Work Order ID 97630

Item Name: Replacement Skidtube

DESIGN	DRAWN BY	DART AEROSPACE USA, INC. PORT HADLOCK, WA
CP	PH	
CHECKED	APPROVED	DRAWING NO. REV. D
		D3274 SHEET 1 OF 4
DATE		TITLE SCALE
06.12.19		SKIDTUBE ASSEMBLY NTS

DRAWING NO.	TITLE	REV.	DART AEROSPACE USA, INC	D.E.O. NO.	SHEET NO.	SCALE
D3274	SKIDTUBE ASSEMBLY	D	ENGINEERING ORDER	D3274-D-1	SHEET 1 OF 1	NTS

DETAIL F: END FINISHING DETAIL

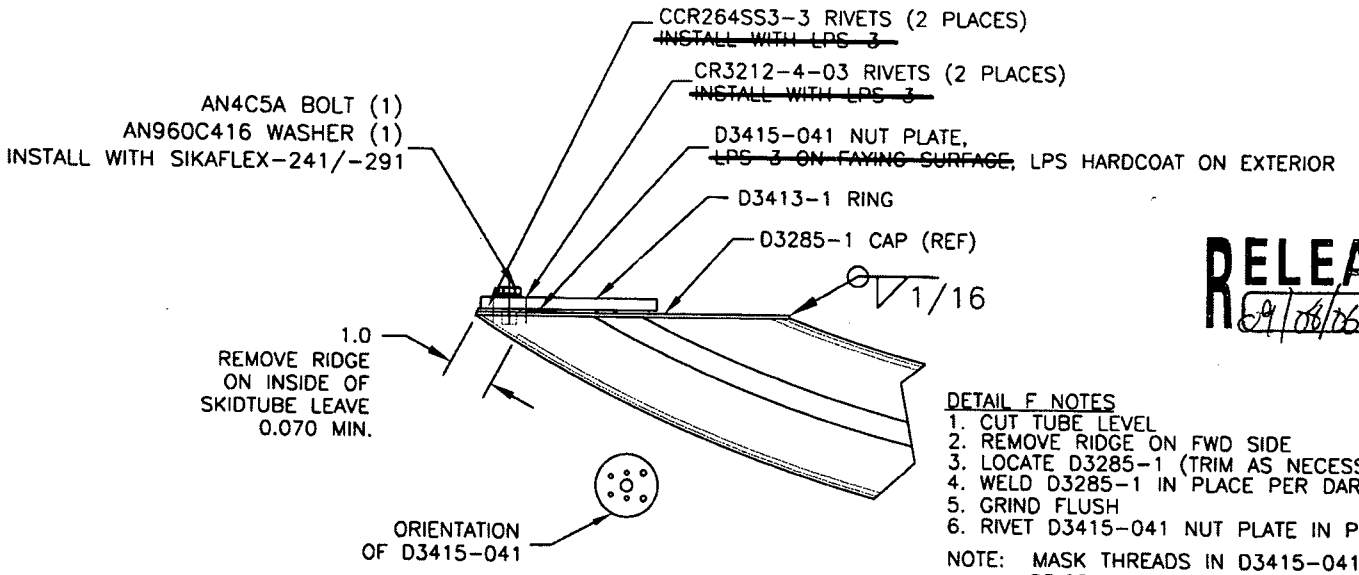
AMEND NOTE 8: "~~SPRAY INSIDE OF TUBE WITH A COAT OF LPS LABORATORIES 'LPS 3' AFTER FINISH AND INSTALLATION OF INSERTS.~~ COAT ALL EXPOSED FASTENERS WITH LPS LABORATORIES 'LPS PROCYON' AFTER FINAL ASSEMBLY, CLEAN EXCESS OFF POWDER COATING WITH MEK DEGREASER."

AMEND DETAIL F AS SHOWN:

DETAIL F NOTES
1. CUT TUBE LEVEL
2. REMOVE RIDGE ON FWD SIDE
3. LOCATE D3285-1 (TRIM AS NECESSARY)
4. WELD D3285-1 IN PLACE PER DART QSI 004
5. GRIND FLUSH
6. RIVET D3415-041 NUT PLATE IN PLACE
